Addendum No. 1: Dated August 3, 2021, to bidding documents for the Water Treatment Plant Improvements, Town of Culpeper, Virginia, WW Associates Project No. 219044.00.

From: WW Associates

This addendum forms a part of the bidding documents and modifies the project manual and drawings dated July 9, 2021. Acknowledge receipt of this addendum in the space provided on the bid form. Failure to do so may subject the bidder to disqualification.

Drawing No. C-3 – Existing Conditions and Demolition Plan – Plan View

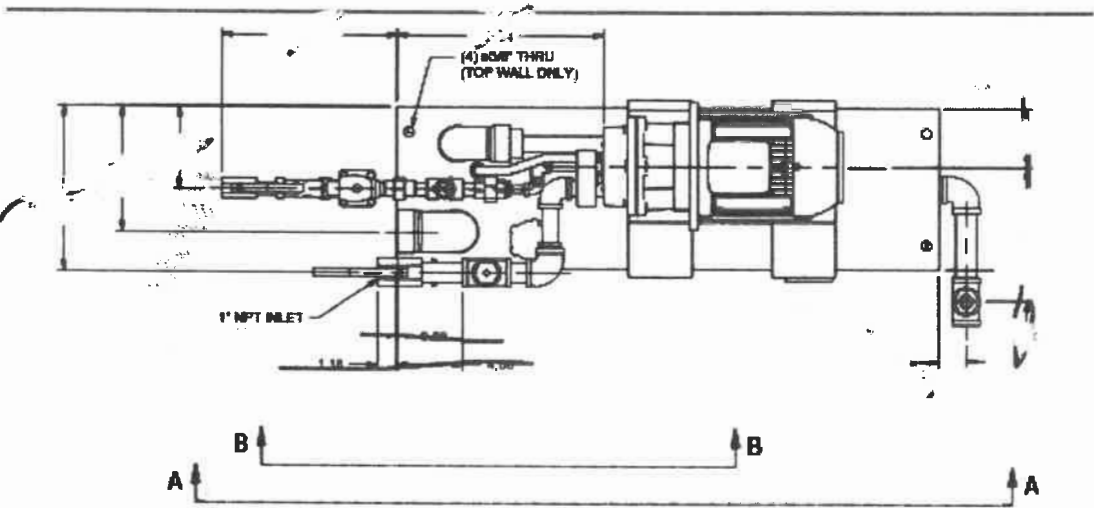
Add the following note:

1. Remove and replace two (2) existing vacuum pumps with new Owner-furnished vacuum pumps.

Delete the following note:

1. “Demolish 4-inch air scour piping (location shown approximate only)”.

VACUUM PUMP ASSEMBLY
(TYP OF 2) Sketch 1 NTS

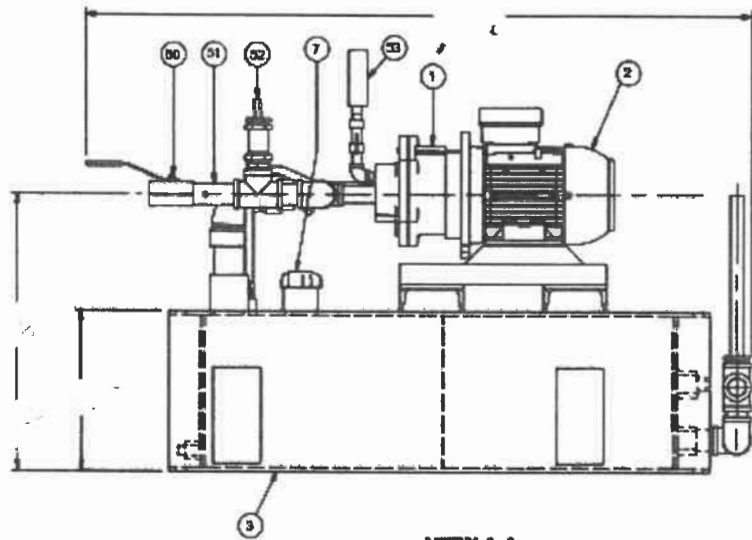
Add Sketch 1 and Sketch 2, attached herein.

VACUUM Pump Assembly
SKETCH NO. 2 (TYP OF 2) NTS

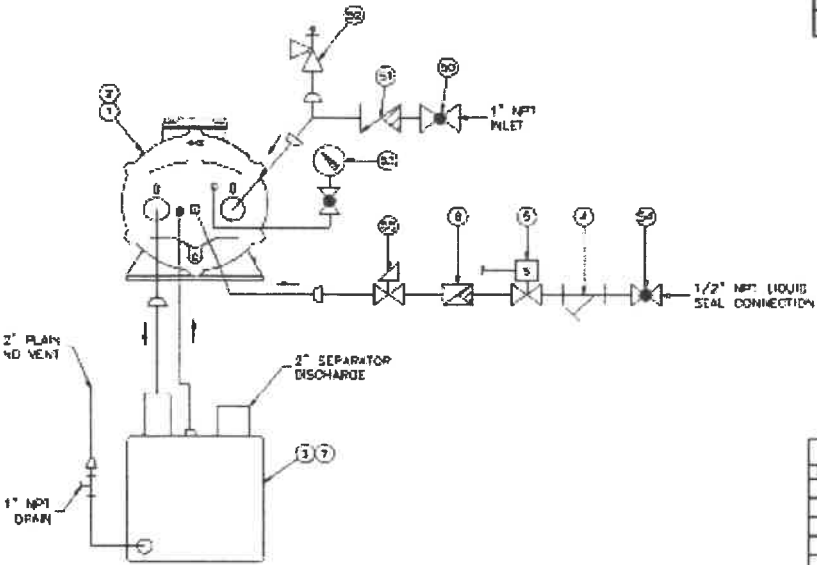
NOTE: INSTALL PUMPS & PIPING AS SHOWN.
 BILL OF MATERIAL IS OWNER FURNISHED BY SUEZ.
